*Preliminary Consultation*  
**MONTGOMERY COUNTY HISTORIC PRESERVATION COMMISSION**  
**STAFF REPORT**

<b>Address:</b>	7315 Brookeville Rd., Chevy Chase	<b>Meeting Date:</b>	1/21/2026
<b>Resource:</b>	Individually Listed Master Plan Site <b>Simpson Family House (35/72)</b>	<b>Report Date:</b>	1/14/2026
<b>Applicant:</b>	Paul and Brandy Carlson Matt McDonald, Architect	<b>Public Notice:</b>	1/7/2026
<b>Review:</b>	Preliminary Consultation	<b>Staff:</b>	Dan Bruechert
<b>Proposal:</b>	Partial demolition, construction of new one-story rear addition and screened porch, and hardscape alterations.

**Figure 3: Approved 2021 rear elevation (left) and proposed revision (right).**

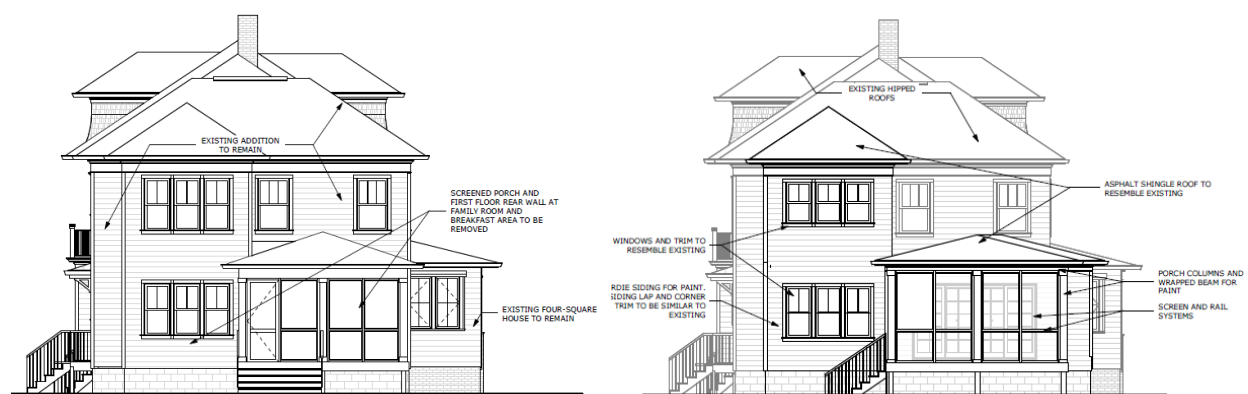
Staff finds the materials are appropriate, as they are consistent with what the HPC previously approved for new construction at the subject property several years ago.

Figure 4: Proposed floorplan with the sections discussed in the Staff Report labeled.

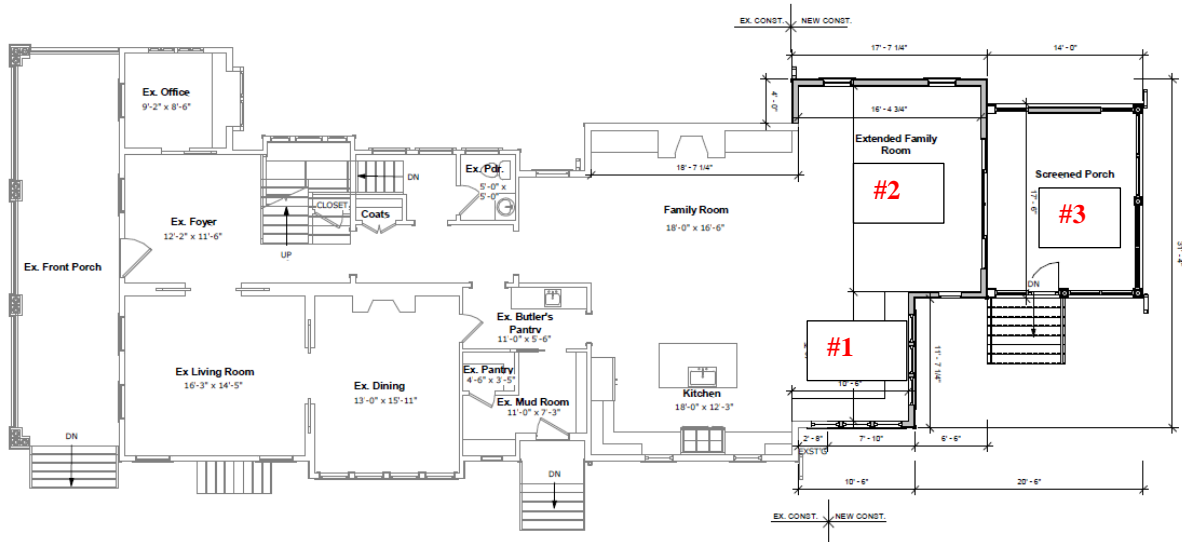
In the southeast corner of the house, the applicant proposes to construct an addition, approximately 7' × 11' 7" (seven feet deep by eleven feet, seven inches wide). This section of the addition (shown as #1) will have a hipped roof with a triple sash window assemblies on both the first and second stories of the south and east elevations. This addition is inset from the 2021 addition by at least two feet. Staff finds this section of the addition reads a new construction separate from the historic Foursquare. Staff finds that while this construction will add to the massing, it does not detract from house's historic form and finds the design is compatible with the historic house detailing (see Fig. 6). Staff finds this portion of the rear addition is appropriate under 24A-8(b)(2) and *Standards* #2, 9, and 10.

Staff finds even though the addition projects beyond the wall plane, it is appropriate for several reasons. First, the proposed addition is only one-story tall, which minimizes the impact of the addition's overall massing to the historic portion of the Simpson House (per *Standard #2* and 24A-8(b)(2)). Second, this section of the addition is more than 20' (twenty feet) to the rear of the historic rear wall plane. This amount of separation ensures the addition reads as distinct construction that is differentiated from the historic (per *Standard #9*). Third, this section of the addition only touches new fabric, so it will not impact any of the historic materials at the Master Plan Site. Fourth, it will be feasible to demolish this portion of the addition in the future and return the house to its historic configuration (per *Standard #10*).

The final portion under consideration is the proposed screened in porch (#3 in the floorplan shown in *Figure 4*). This will be constructed to the rear of the norther portion of the addition and will be covered in a hipped roof, with wrapped columns and beams, and a new set of side-loading stairs. The majority of the north elevation of the porch will have a solid wall of fiber cement clapboards, flanked by two large screens. The screened in porch measures 14' × 17' 6" (fourteen feet deep by seventeen feet, six inches wide) which is nearly identical to the size of the existing screened in porch. Staff finds the proposed screened-in porch will largely be obscured by the addition to its west (discussed above). Staff additionally finds that the materials and design are consistent with the HPC's previously approved rear porch.

Figure 10: Proposed landscape plan.

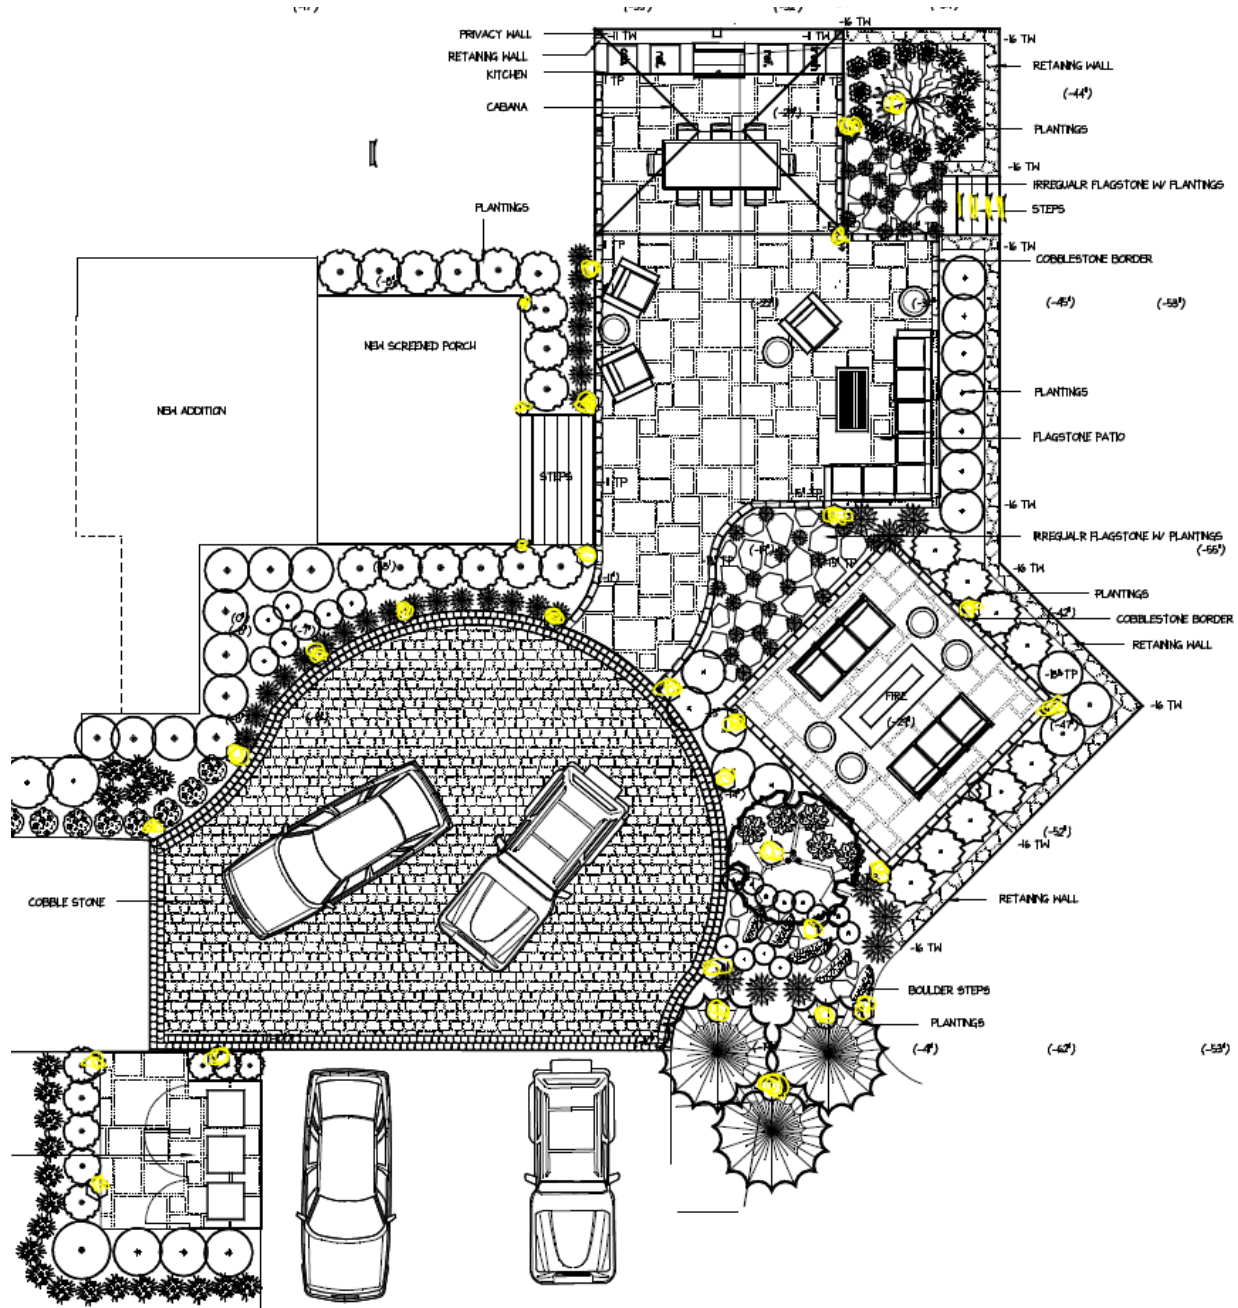
Generally, Staff finds the type of work proposed is compatible with the site and with dimensions and full specifications, Staff expects to support the work. Staff notes the run of the stairs on the landscape plans and the submitted architectural plans is not consistent and should be clarified before the HAWP submission.

Staff has concerns about the compatibility of the proposed cabana and its privacy wall. These concerns stem from the location proposed, which is approximately 10' (ten feet) of the rear wall of the screened-in porch. This proximity will add to the overall sense of mass of the house and risks approaching a tipping point where the new construction (including the 2021 addition) overwhelms the historic construction and fails to satisfy 24A-8 and the *Standards*. As dimensions, elevations, and materials for this structure were not provided, Staff is unable to provide more substantive feedback on this feature. Staff finds that to be compatible with the character of the site, any cabana needs to be placed entirely behind the house and further separated from the house and its porch.

The final landscape plan submission needs to include:

- Dimensions and lot coverage calculations;

- Elevation drawings for any proposed structures;
- The height of any retaining walls or privacy walls; and
- Materials and design specifications for any storage or trash enclosures.
